GROUP
CampaignMODEL
SportageNUMBER
017DATE
August 2000

Technical Service Bulletin

SUBJECT:**Owner Notification Campaign - Sportage Owners Manual**

4000000000
6-5

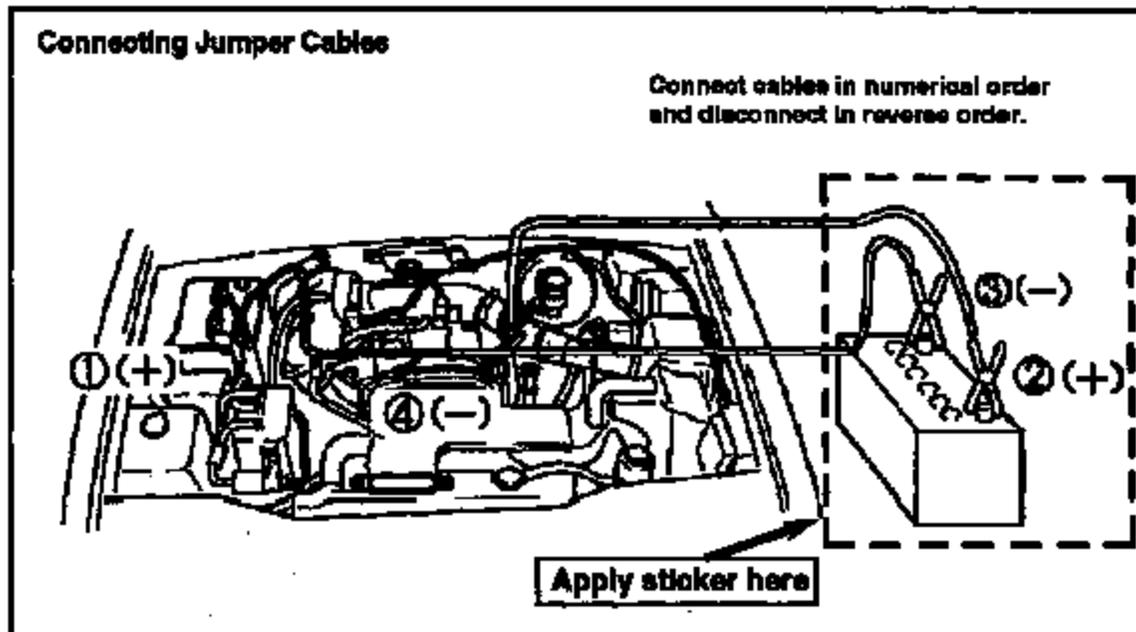
This bulletin provides information related to a owner notification on 2000 model year Sportage to correct an error in the Owners Manual. The jump starting diagram in the Owners Manual is incorrect. If the diagram were followed, spark/arcing could cause the battery to explode causing potential serious injury to bystanders.

1. Remove Owners Manual from Information packet in glove box.
2. Open Owners Manual to page 6-5.
3. Apply supplied sticker with revised battery jumper connections in location shown below.

To correct this error, Kia is sending a letter and correction sticker to all 2000 model year Sportage owners asking them to apply a correction sticker to page 6-5 in their Owners Manual.
